STAFF RECOMMENDATION 1200 North 14th Street December 19, 2018

Application: New Construction—Addition and Outbuilding; Setback
District: Eastwood Neighborhood Conservation Zoning Overlay
Council District: 06
Map and Parcel Number: 08301034100
Applicant: Kaitlyn Smous, Nine12 Design
Project Lead: Melissa Baldock, melissa.baldock@nashville.gov

Description of Project: Application is to construct a rear addition and a carport. The addition requires a setback determination. Base zoning requires a five foot (5') side setback, and the applicant is proposing an addition that is one foot, two inches (1'2") from the side property line.

Figure 1. 1200 North 14th Street.

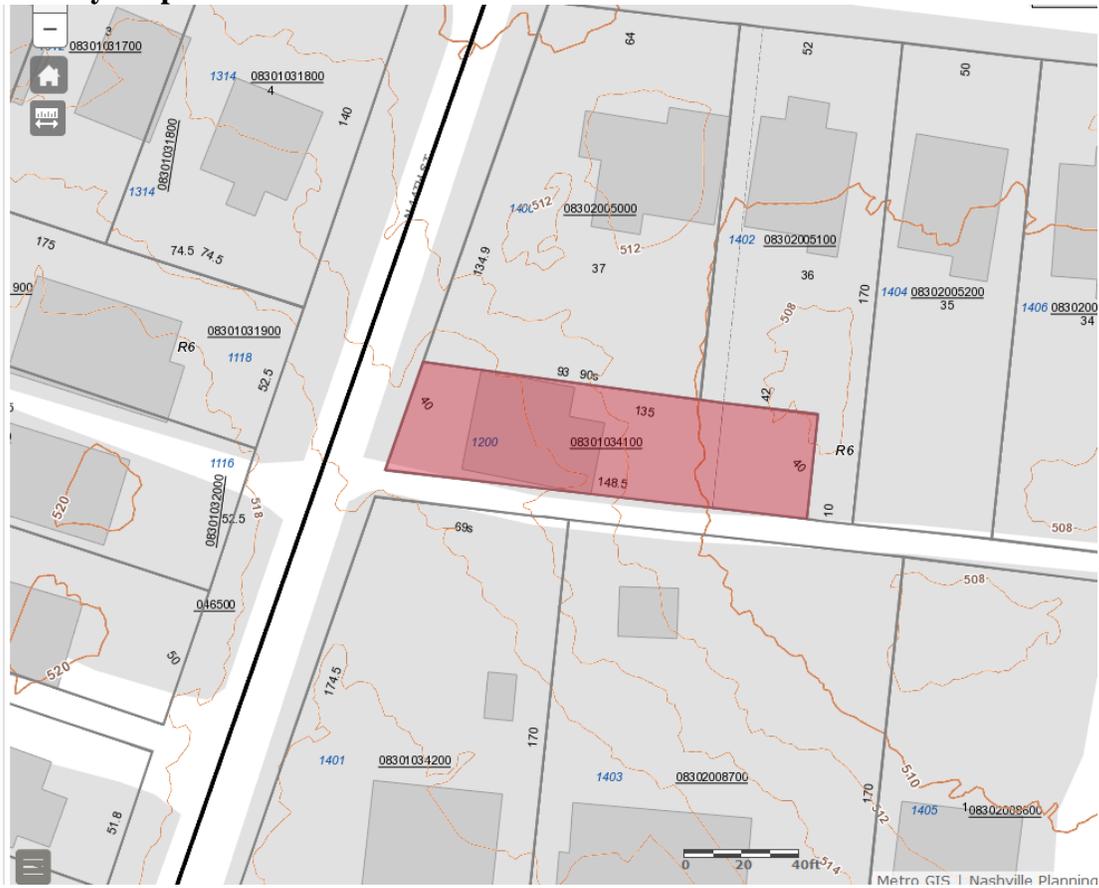
Background: 1200 14th Avenue North is a c. 1938 Tudor Revival style house that contributes to the historic character of the Eastwood Neighborhood Conservation Zoning Overlay.

Figure 2. The addition will attach to the existing addition

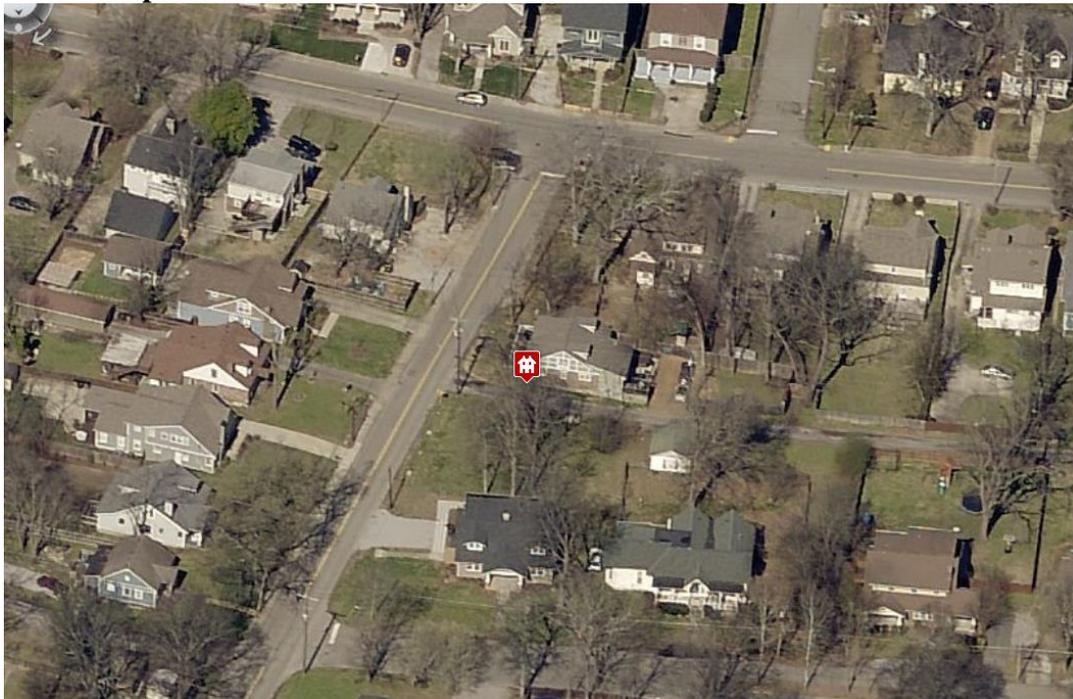
Height & Scale: The house is one and a half stories in height. The addition is just one story and is seven feet, six inches (7'6") lower in height than the historic house. Staff finds this to be appropriate. The addition will attach to an existing addition (Figure 2). On the right side, the addition will be inset one foot (1') from the existing addition, and will

be inset approximately eighteen inches (18") from the back corner of the historic house. The addition will be inset nine feet (9') on the left side, matching the inset of the existing addition. Staff finds these insets to be appropriate. The addition will have a depth of thirty-one feet (31') and will be approximately six hundred and ten square feet in footprint (610 sq. ft.). By comparison, the historic house is thirty-seven feet (37') deep, not including the existing addition which is ten feet, six inches (10'6") deep. The historic house's footprint is approximately one thousand, two hundred and thirty-seven square feet (1,237 sq. ft.), not including the existing addition, which is approximately three hundred square feet (300 sq. ft.) in footprint. Staff finds that the addition's height and scale are sufficiently subordinate to the historic house and meet Sections II.B.1.a., II.B.1.b., and II.B.2. of the design guidelines.

Figure 3. The site plan highlights the unusual angling of the property line on the right side, along the alley.

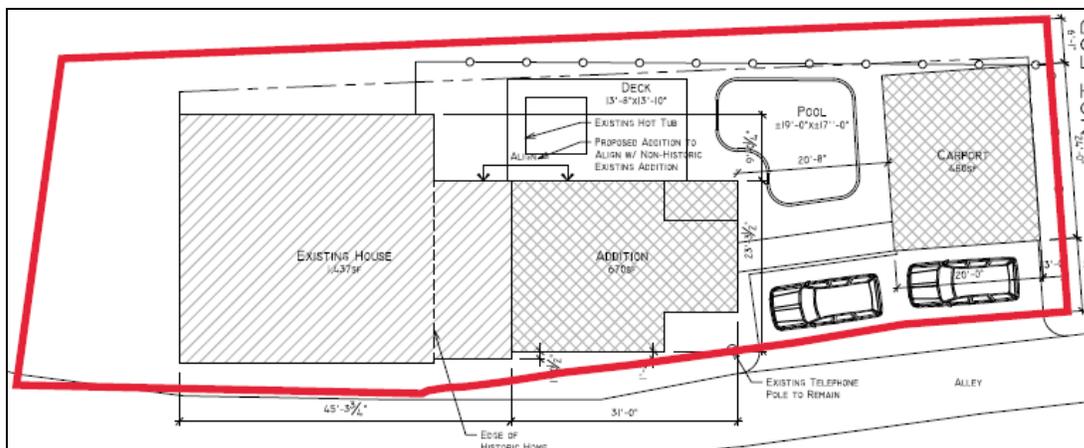
Setback & Rhythm of Spacing: The proposed addition meets the base zoning setbacks on the left and rear sides. On the left, the addition is at least nineteen feet (19') from the side property line. The addition is over forty feet (40') from the rear property line. The right side of the addition, however, does require a setback determination. Even though the addition is inset from the historic house appropriately, the addition sits closer to the side property line because the lot angles unusually towards the back (Figures 3, 4, and 5). The property line with the odd angle along the side abuts an alley.

Base zoning requires a five foot (5') side setback from the side alley property line, and the applicant is proposing a minimum setback of one foot, two inches (1'2"). Because of the angle of the lot, the addition's side setback varies one foot, two inches to four feet (1'2" -4').

Staff finds the proposed side setback determination to be appropriate for several reasons. First, the historic house already does not meet the base zoning setback of five feet (5'); it is approximately three feet, six inches (3'6") from the side property line. Also, the

addition is inset appropriately and is designed so that it does not impact the historic fabric of the historic house, as it ties entirely into the existing addition. Further, the odd shape of the lot creates an unusual situation where part, although not all, of the addition is closer to the property line than the historic house, even though it is inset. Lastly, the addition will not directly affect any neighboring residences, as it abuts an alley. Staff therefore finds that the proposed setbacks and rhythm of spacing meet Sections II.B.1.c. and II.B.2. of the design guidelines.
